**State Significant Development for proposed plant 2 upgrade works – Lot 7 DP1059698 –  
780 Wallgrove Road, Horsley Park – SSD 9601**

The Environment Protection Authority ("EPA") is writing to you in reply to your email dated 2 October 2019 in relation to the Department of Planning, Industry and Environment's ("DPIE") public exhibition of the Environment Impact Statement ("EIS") for the proposed plant upgrade for Plant 2 at Austral Brickworks.

## Attachment A

Figure: 2018 Pacific Environment meteorological data (Left) and 2019 Airlabs Environmental meteorological data (Right).

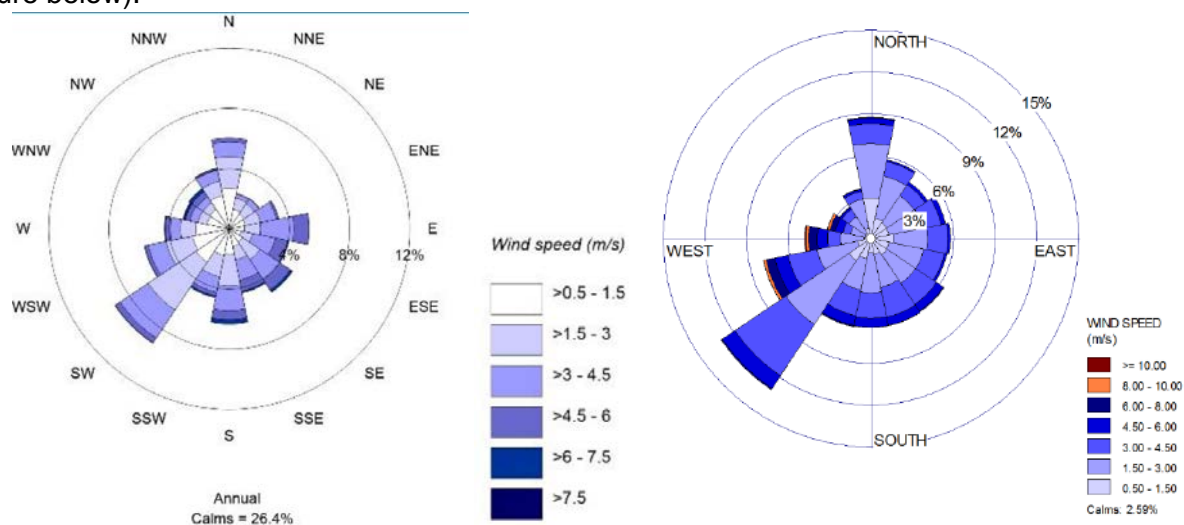
The EPA notes that the 2018 AQIA (Pacific Environment, section 4.3) shows different wind fields and a much higher % of calms than the AQIA report modelling the proposed Plant 2 upgrade (see Figure below).

The EPA advises that the significant inconsistencies of meteorological data by the same proponent is questionable and that the significant difference in the percentages of calm would influence the dispersion of emissions, potentially changing the results and conclusions of the assessment.

The EPA **recommends** that a revised AQIA be prepared that demonstrates the meteorological data used for dispersion modelling adequately describes the expected meteorological patterns at the site.

The EPA **recommends** that additional information be provided on long-term site-representative meteorological data collected from one or more monitoring stations and a detailed discussion on the prevailing meteorological conditions at the site include an analysis of wind speed and direction, stability class, ambient temperature and mixing height, to demonstrate that the meteorological data produced by the model is appropriate for use in dispersion modelling.
